Service Bulletin SB-0025

Subject: Wire Routing Improvements

Effectivity: K003 – K021

Affected Model(s): E1000, E1000 GX

e. Instrument Panel - Main Cabin Harness

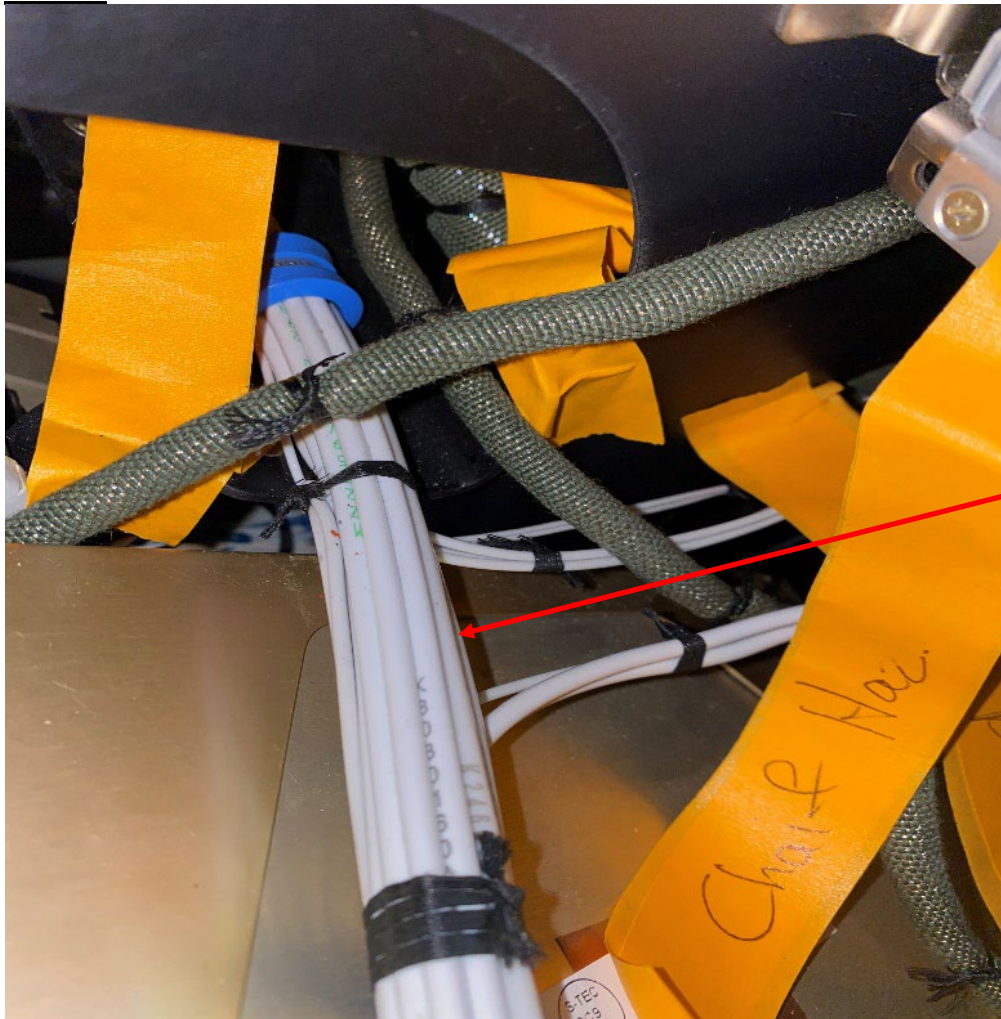
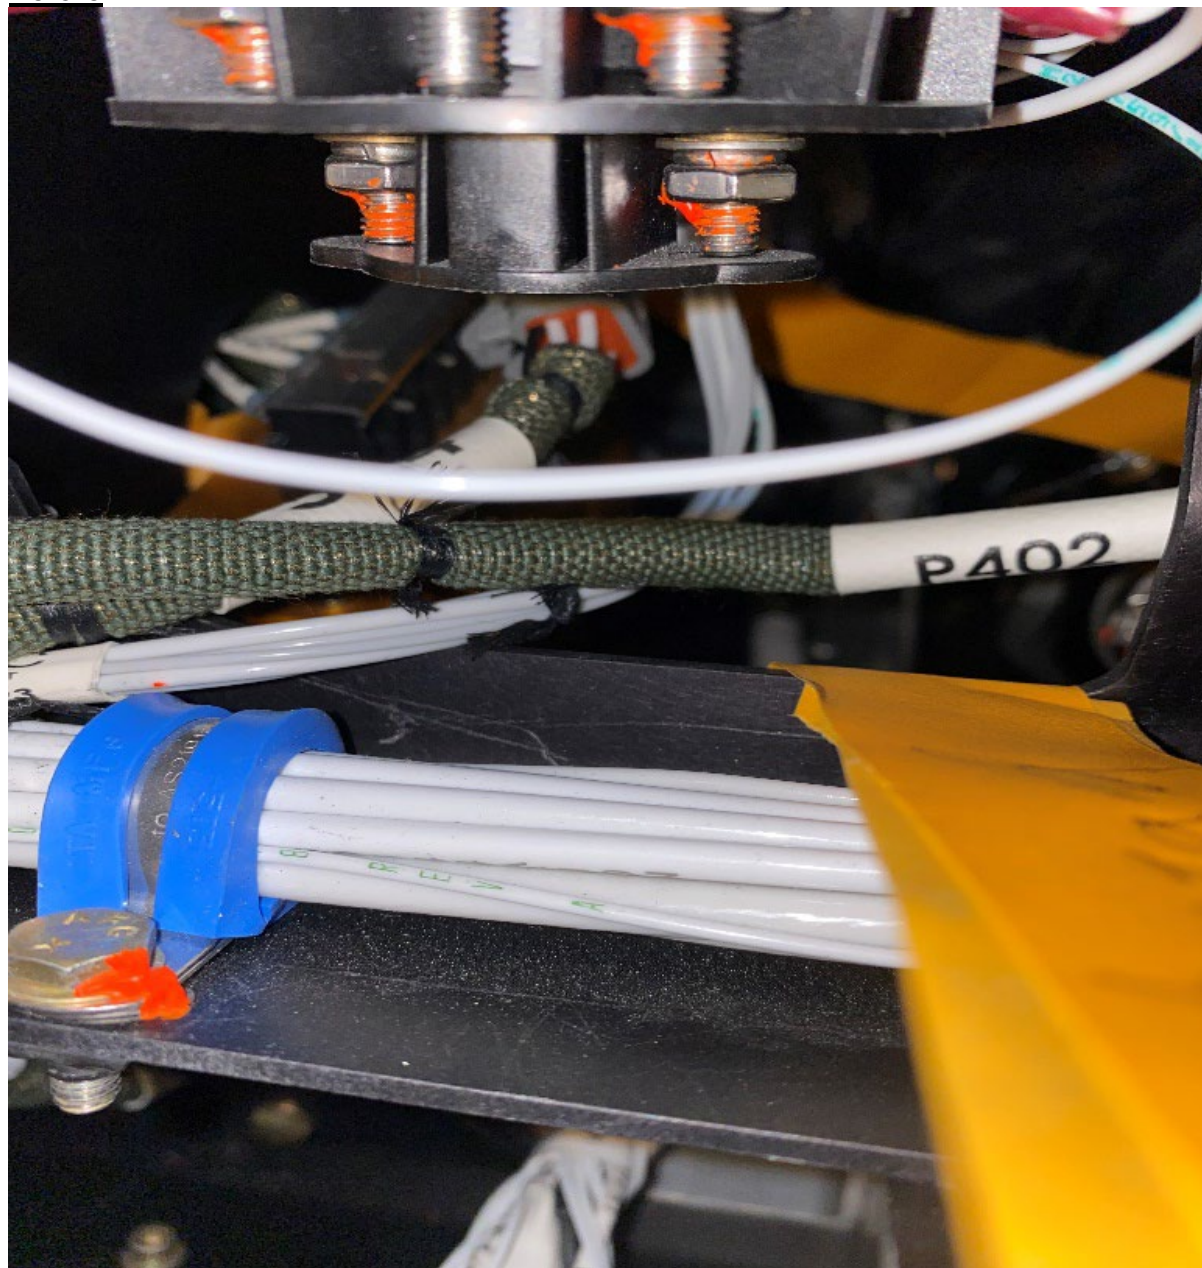
Action: Wires in the forward trough, behind both PFD's & MFD, along the front of the instrument panel, need Roundit on the 10 AWG harnesses and surrounding wires.

Exposed harness.

Install Roundit.

f. Instrument Panel – 12 VDC Converter

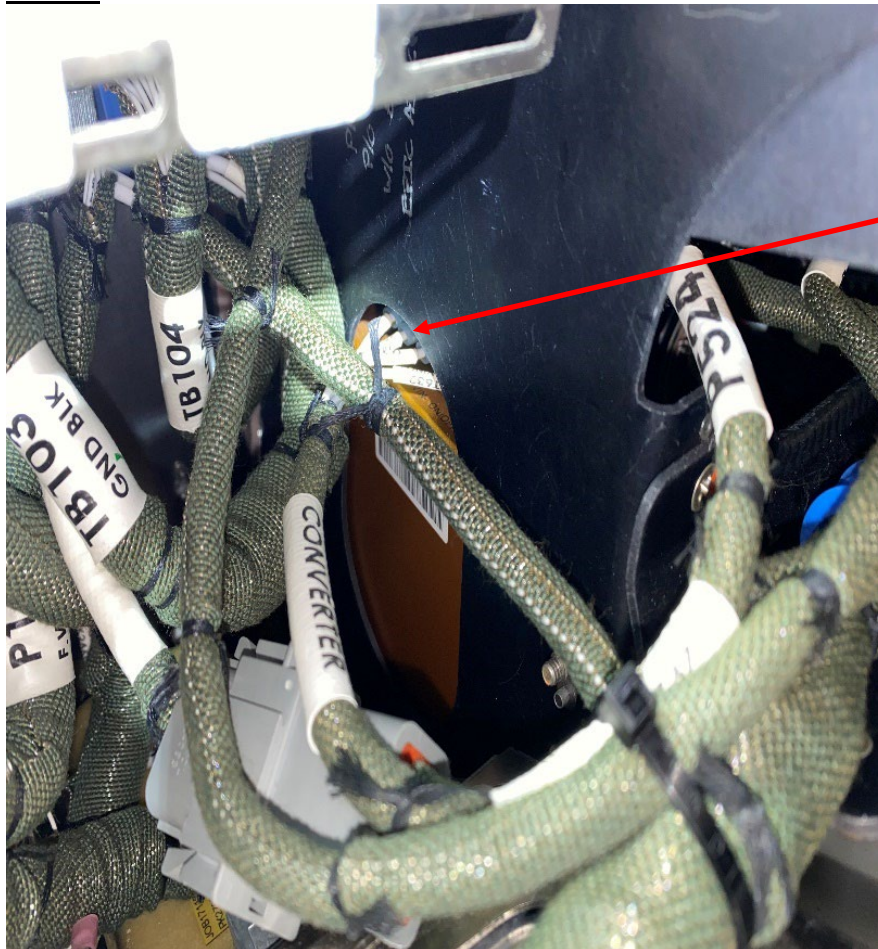
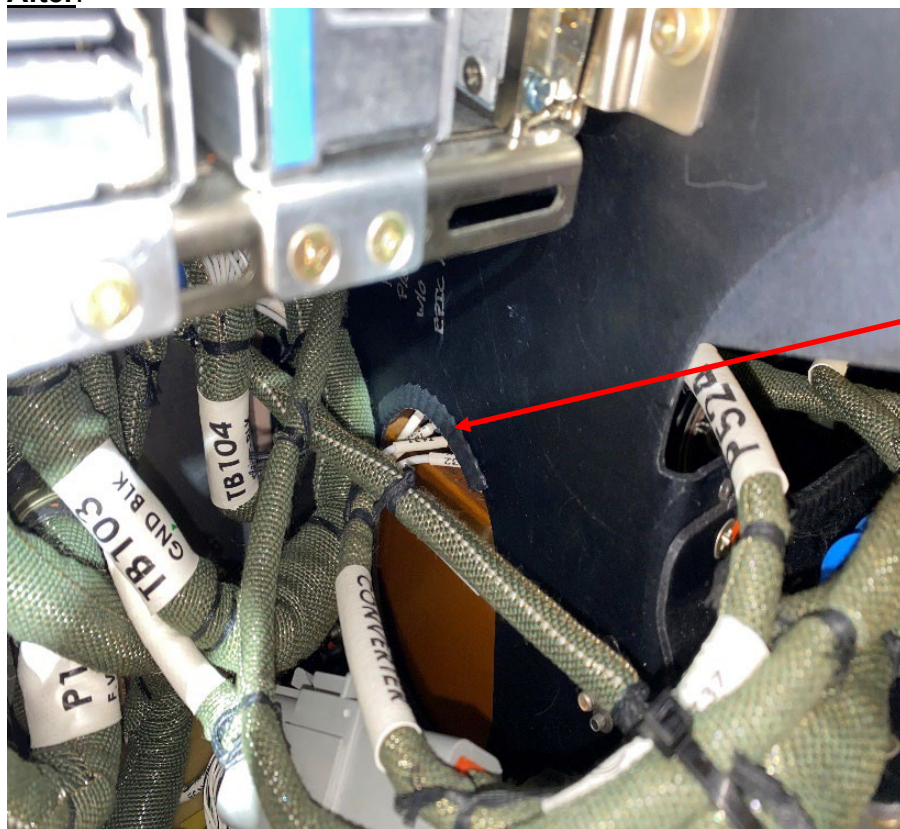
Action: Add edge protection on the exposed metal edges where harness crossed over to the converter.

Chafe hazard.

Add edge protection.

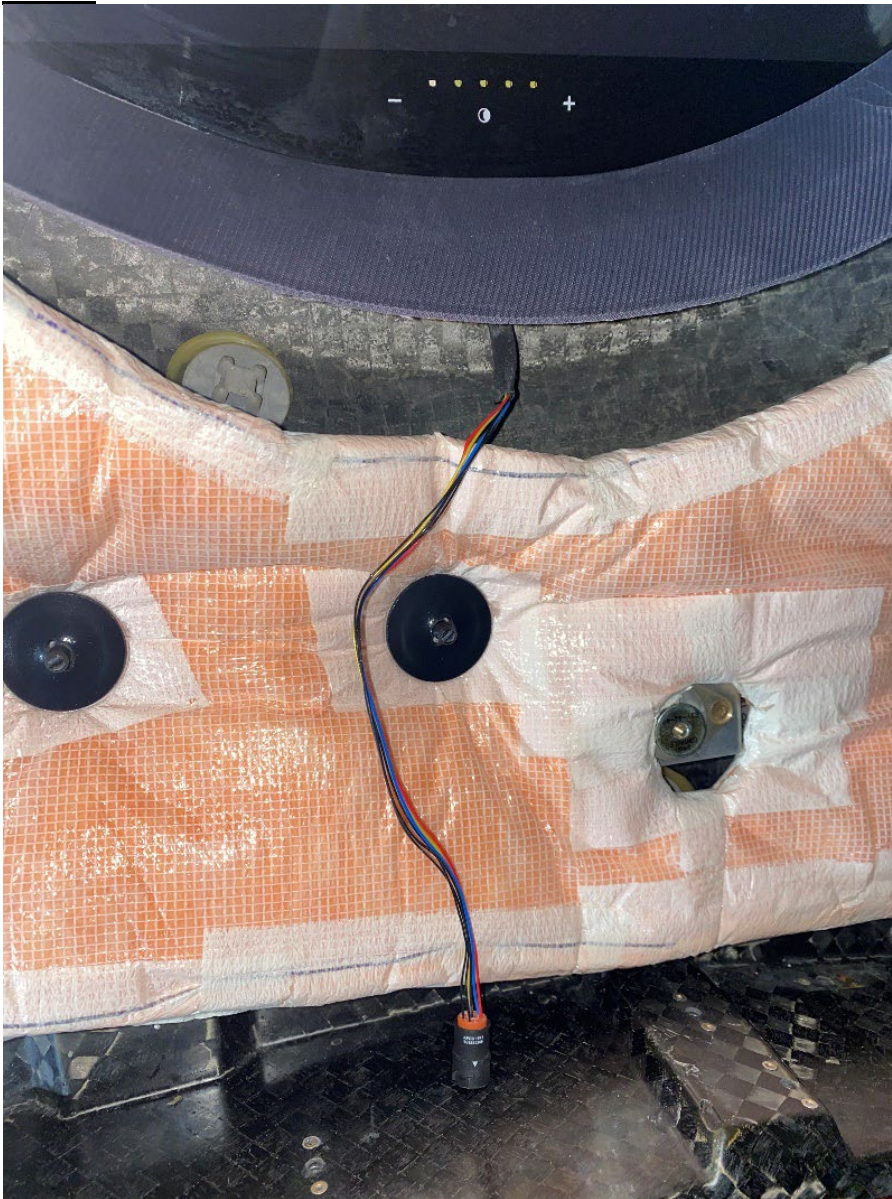
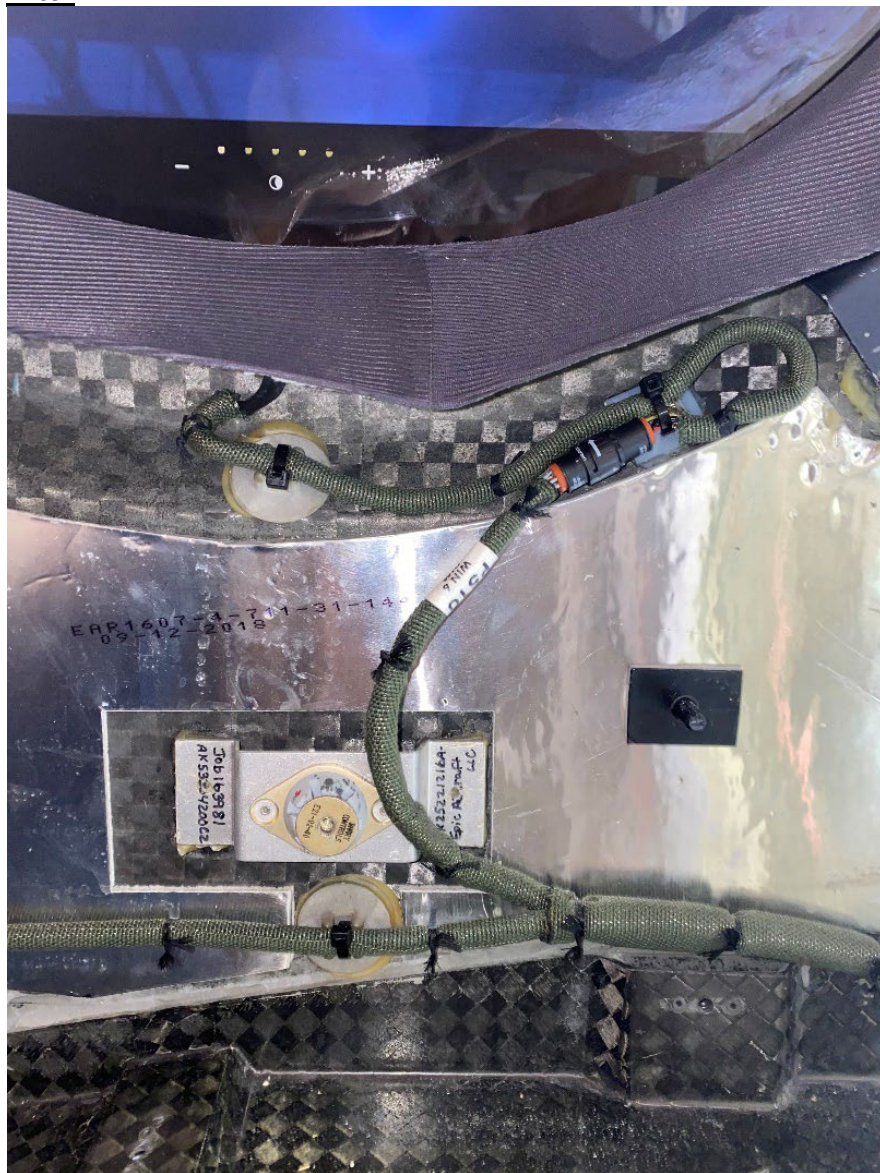
Action: Add Roundit to all windows dimmer wires.

I. Co-Pilot's Armrest – COAX Cables

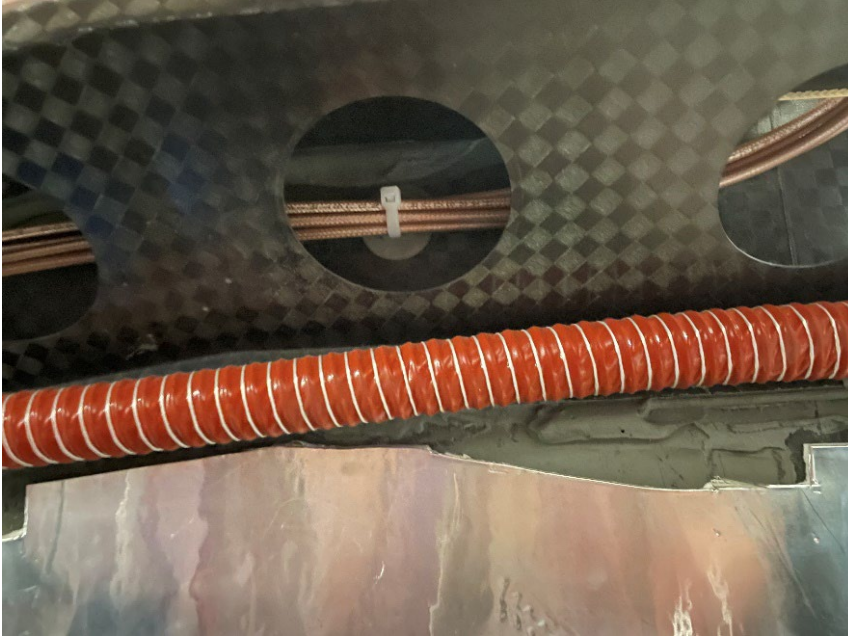
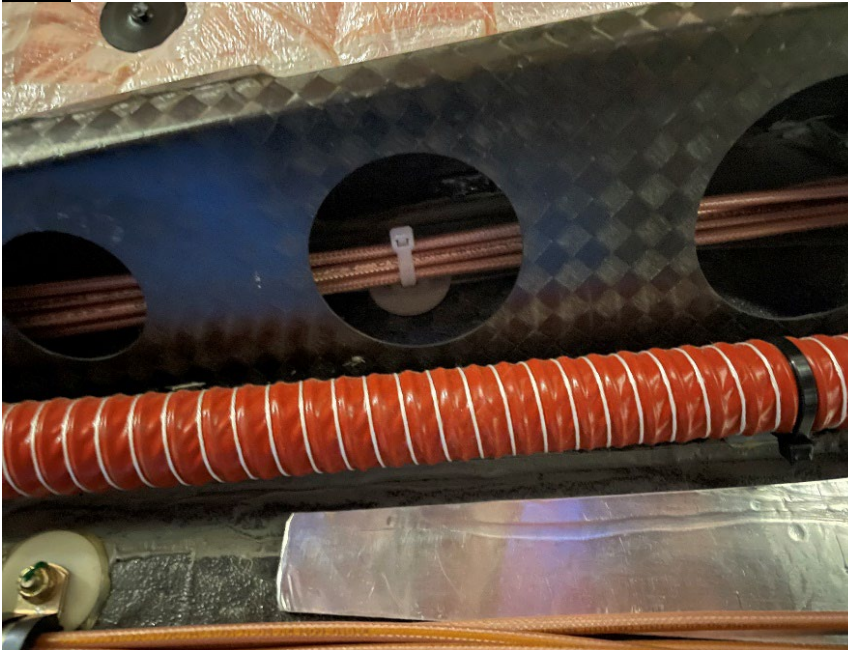
Action: Add tie mounts at two locations for COAX antenna wires installed in the co-pilot's armrest.

m. Pilot's Floorboard – Electrical Connector

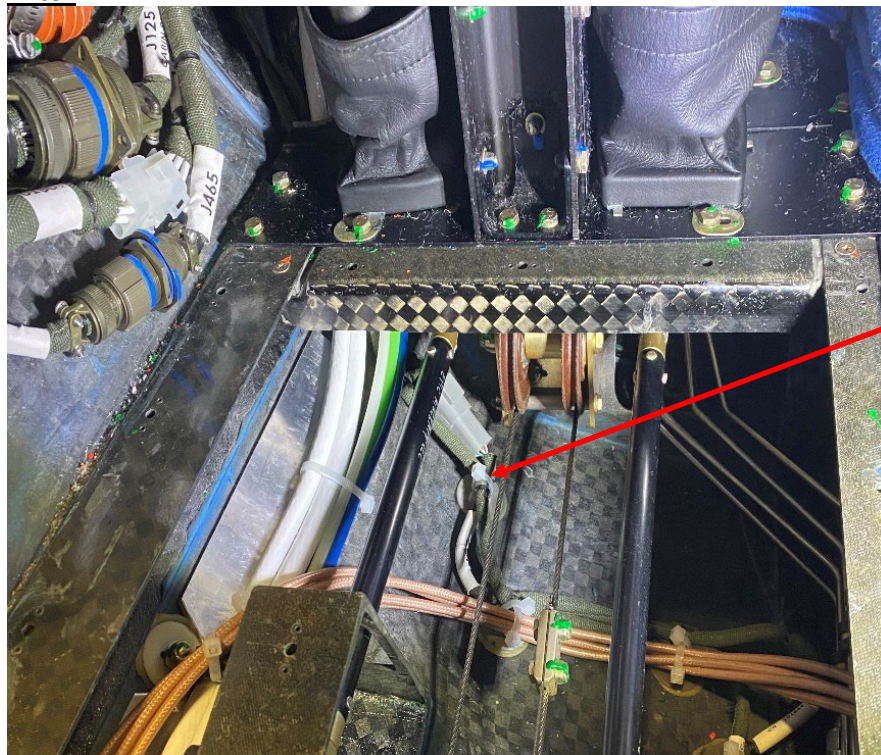
Action: Secure connector under pilot's floorboard away from moving linkage using a tie mount as shown.

Contact with linkage.

Install tie mount as shown to keep the electrical connector away from the linkage.

n. Vertical Stabilizer

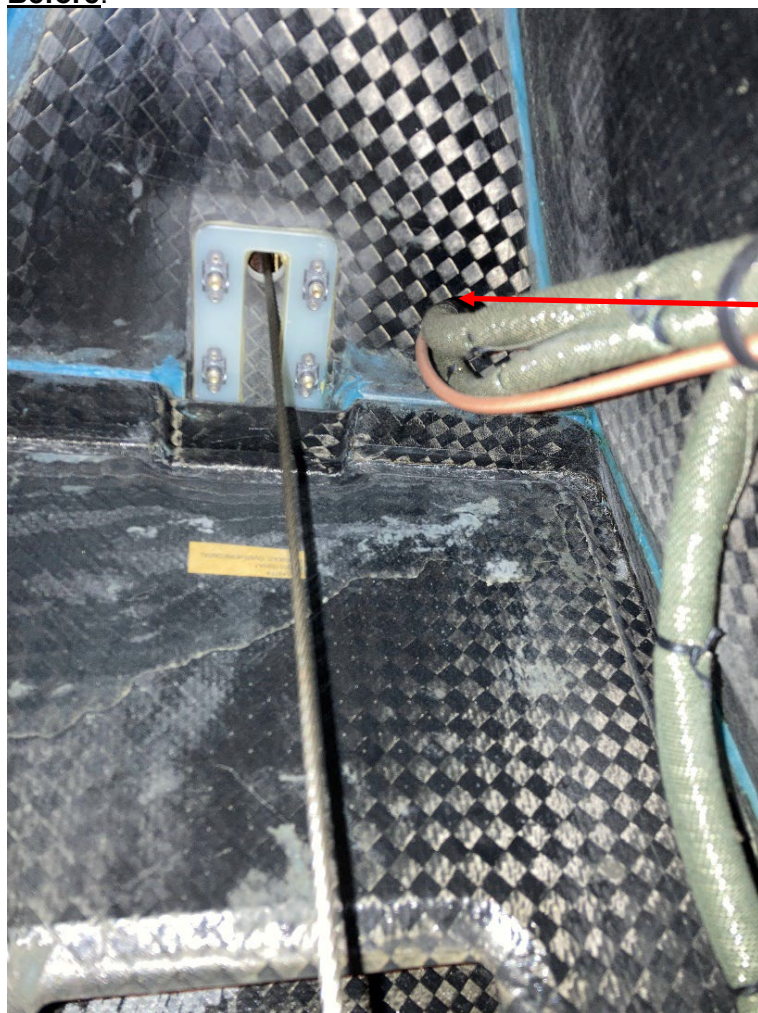
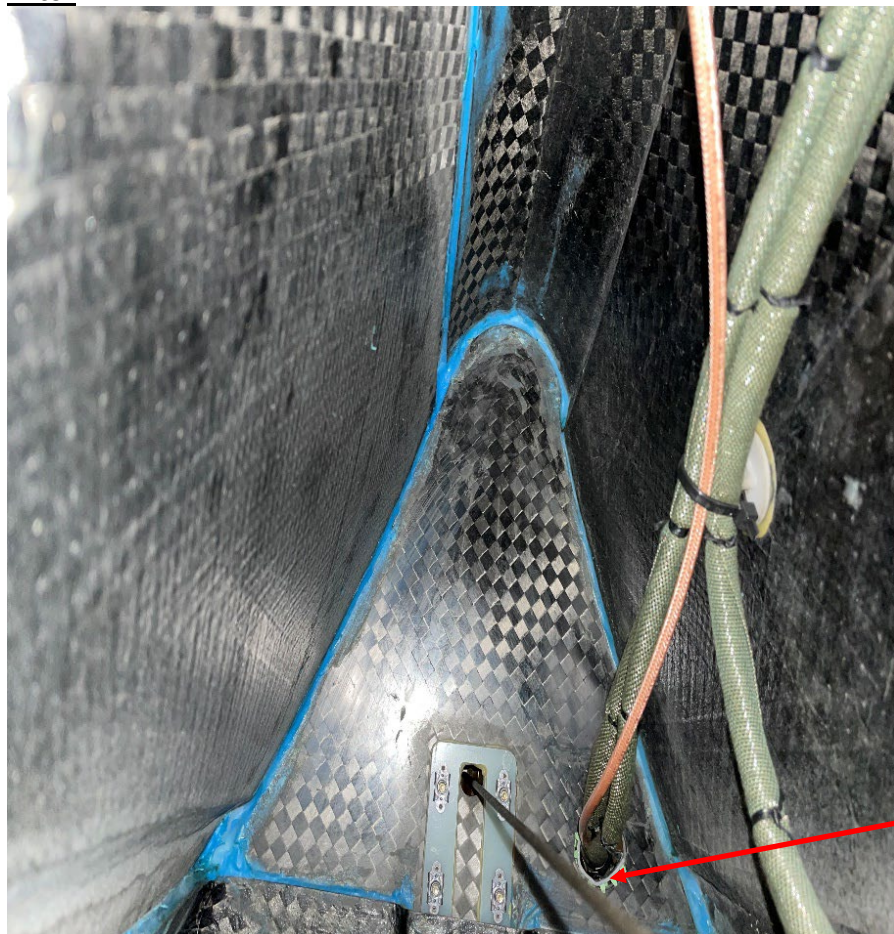
Action: Install edge protection at the pass-through hole.

Chafe hazard.

Add edge protection.
